AEGIS CARKEEK PARK

10002-10022 HOLMAN ROAD

RECOMMENDATION MEETING - DESIGN REVIEW BOARD 10.22.2018
SDCI PROJECT #3027225

PEDESTRIAN EXPERIENCE: HOLMAN ROAD

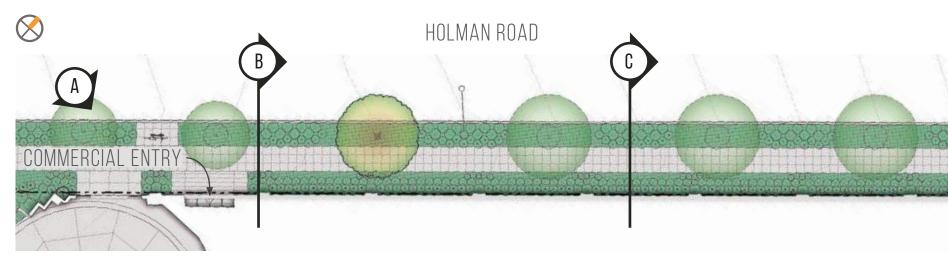
requests an entry to the building and to the commercial area that is recognizable dives below grade. In order to maximize the transparency along holman road, from Holman Road and not only visible and accessible within the Porte Cochere. Pedestrian access from NW 100th Street should also be visible and separate provide access points and sight lines to the residential entry. In response to EDG from vehicles. Treatment may include more windows, display windows, stepped feedback an entry has been added along holman directly into the commercial walls, landscaping, and interesting masonry treatments.

The Board requests a strong connection to Holman Road NW. The Board The site slopes 17' from the sw corner to the ne corner and the project quickly level 1 has 14' floor to floor height. Multiple entry points into the porte cochere space. Architectural detailing such as pilasters, lanterns, brick headers and plantings add interest and pedestrian-scaled language to the facade.

PEDESTRIAN EXPERIENCE: 3RD AVENUE NW

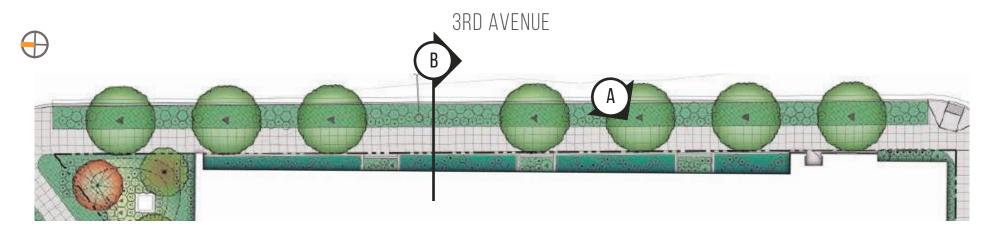
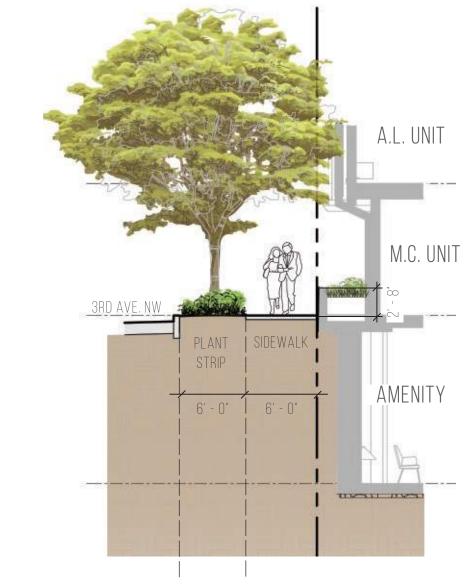
The Board indicated that they prefer to see increased facade transparency, and are interested in seeing the proposed windows retained. Treatment may include Appropriately scaled residential units provide privacy to residents and neighbors alike.

A setback at the street level allows for a dense landscaping buffer between residents and pedestrians and enhances the streetscape along 3rd Avenue.

PEDESTRIAN EXPERIENCE: NW 100TH STREET

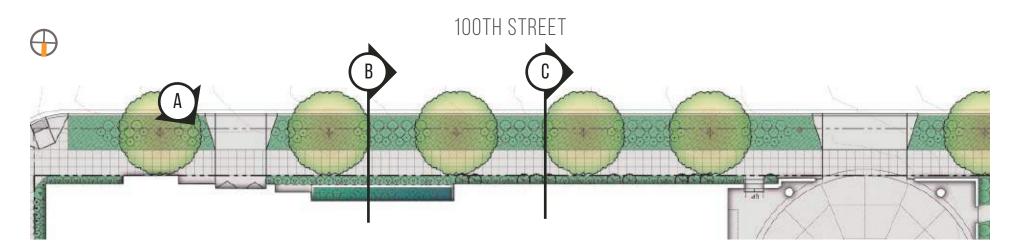
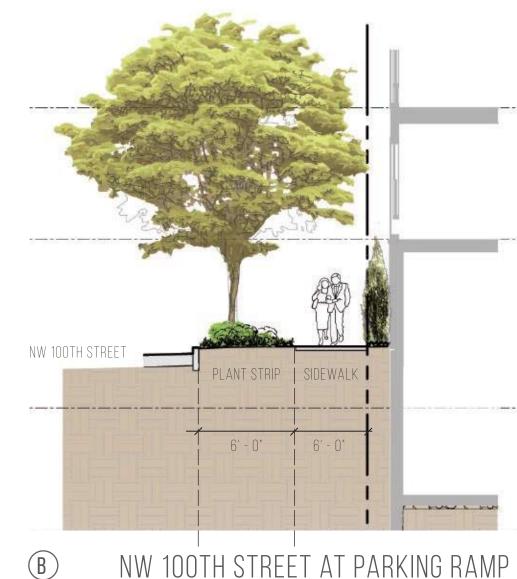
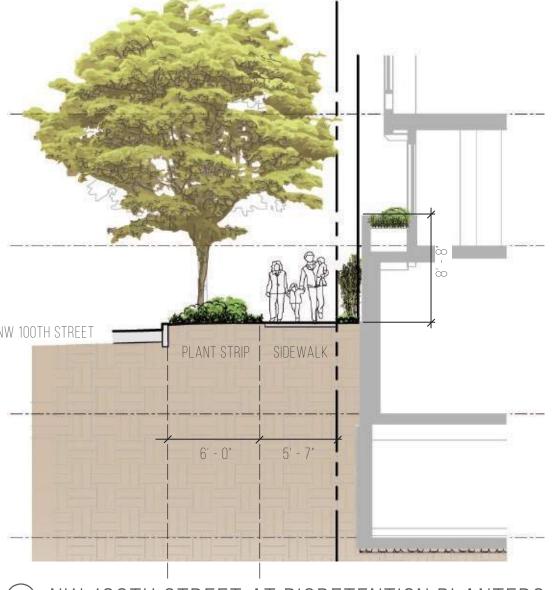
the parking ramp in lieu of blank walls. Treatment may include more bay windows various parking ramp configurations, The proposed ramp location was supported by as above the subject wall, interesting masonry, landscaping, facade art, openings the board at EDG. The proposed layout minimized curb cuts, prioritizes pedestrian with artistic screens, etc.

The board indicated that they prefer to see increased facade transparency even at Due to required vehicle access off of 100th st and steep grade change we explored safety, and limits the impact to the Holman Road facade. High quality materials such as brick and stone are used to create visual interest, while dense plantings and green walls help to break up the facade and provide a pleasant pedestrian experience.

ENTRY SEQUENCE: HOLMAN ROAD PLAZA & PORTE COCHERE

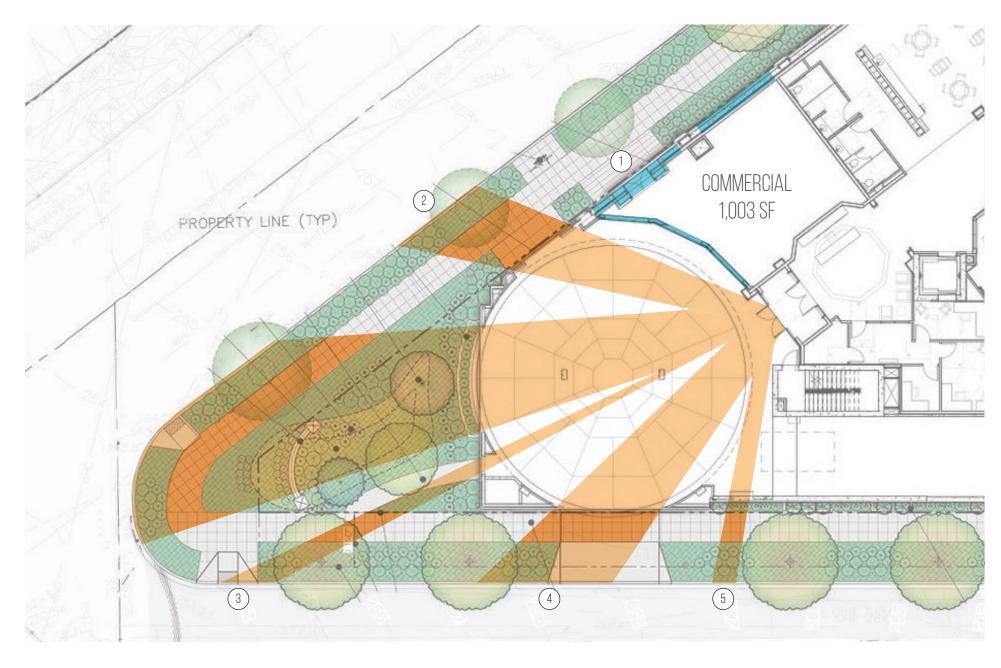
The Board suggested that the northwestern plaza, NW 100th Street, and the The SW corner features decorative plantings, a monument sign, and flagpole that small commercial space are good opportunities for positive street relationships. focuses views toward the SW entry. A second pedestrian access point has been The Board suggests light screening, good landscaping, and where possible entry added along Holman Road to provide a distinct entry to commercial space. Access sequences that are visible and understandable to pedestrians. The Board requests points to the porte cochere are located off of Holman Road, NW 100th St, and wall and landscaping design at Holman Road which minimizes the transition to landscaped area at the SW corner of the site. A raised planter is located in front the public realm.

of the arched opening to the west to clearly mark vehicular access. Openings into the porte cochere have been maximized to provide views to the residential entry.

BUILDING CONCEPT: MATERIAL PRECEDENTS

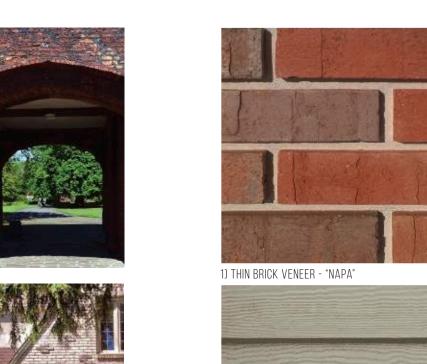
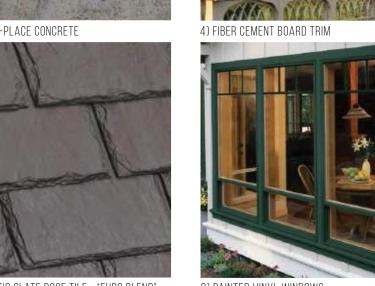
The Board accepted the raised courtyard at Holman Road and the subsequent lack of transparency at the street level. NW 100th Street and 3rd Avenue pose separate challenges, which can be overcome through building modulation, thoughtful landscaping, lighting, and material choice. The Board requested wall and landscape design on all sides of the building which acts to minimize the height of walls.

High quality materials such as brick, stone masonry veneer, and architectural concrete at the base of the building provide scale and texture to the streetscape. Dense landscaping at all street faces add texture and scale to the pedestrian experience. Upper levels provide a variety of different materials including brick, lap siding, fiber cement board, and stucco with half timbering. The roof and mechanical screening are clad in a synthetic slate tile.
